**VILLAGE OF ALGONQUIN
PLANNING AND ZONING COMMISSION
AGENDA**

SUBJECT: *Final Plats and Plans, Trails of Woods Creek PUD*

SUBJECT: **Case No. 2020-04. PW Staff Review #3**
*Trails of Woods Creek Development – Final Plat of Subdivision,
Final Site Plan, Final Engineering, Final Landscaping, and Final Stormwater
Report*

SECTION: NATIVE SEEDING

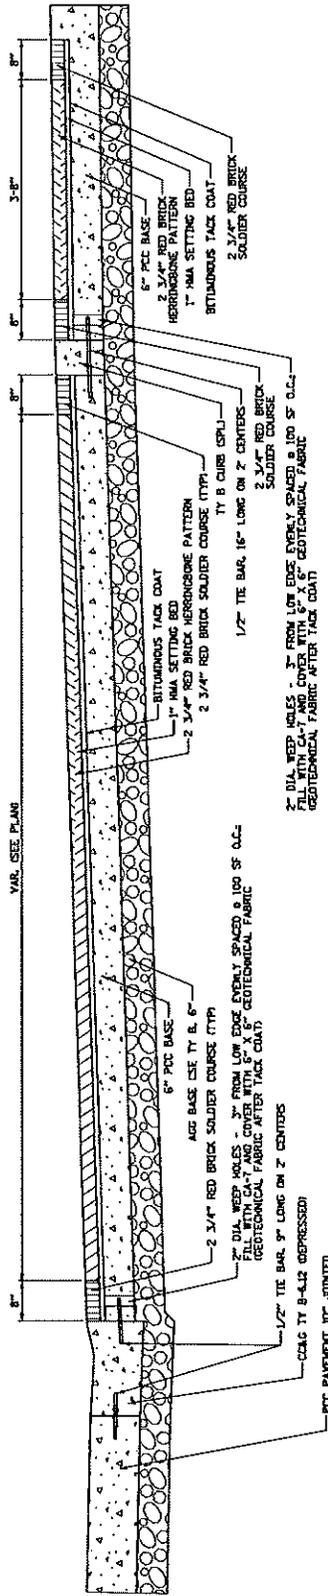
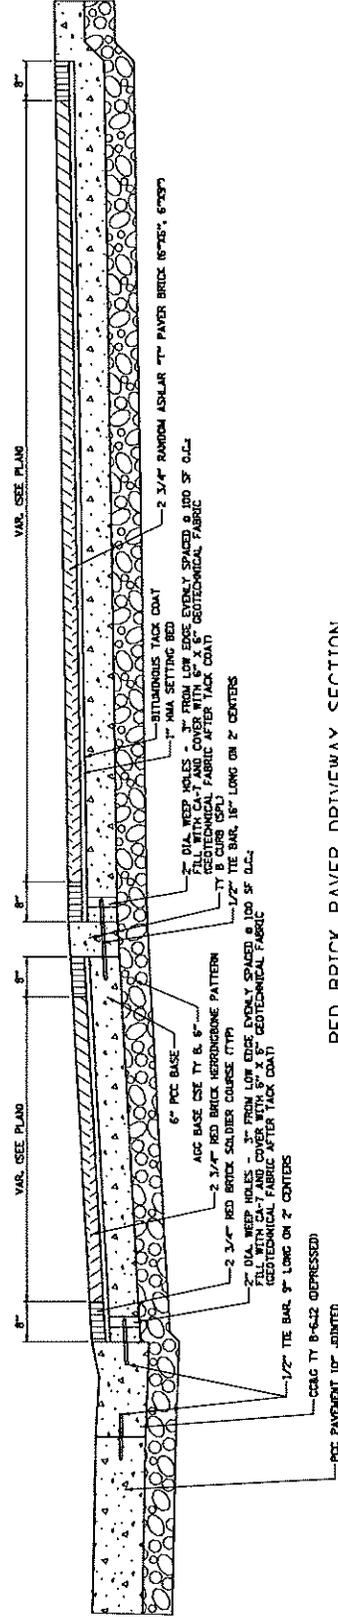
- The Village has implemented dozens of successful ecological restoration projects and requires standard “Vegetation Performance Standards” that are less complex to assess that those listed on Pages 10-11 of the Native BMP & Wetland Buffer Planting/Mitigation Plan. The Village’s standard vegetation performance standards are attached and should be used for this project:

CONSTRUCTION DETAILS

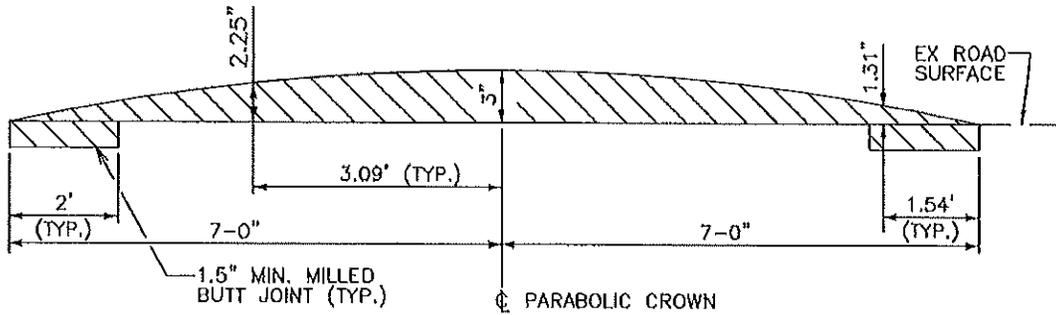
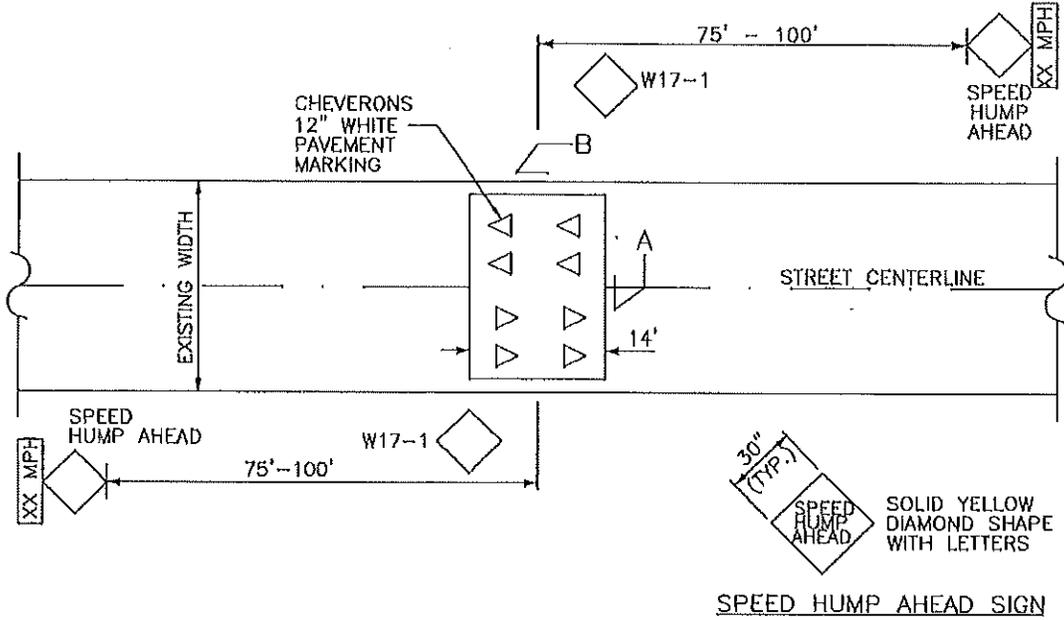
- Sheet 11: Stop signs are not required where street G meets street K and where street F meets street B.
- All medians must have mountable end noses. (see attached detail red cloud dwg. 46).
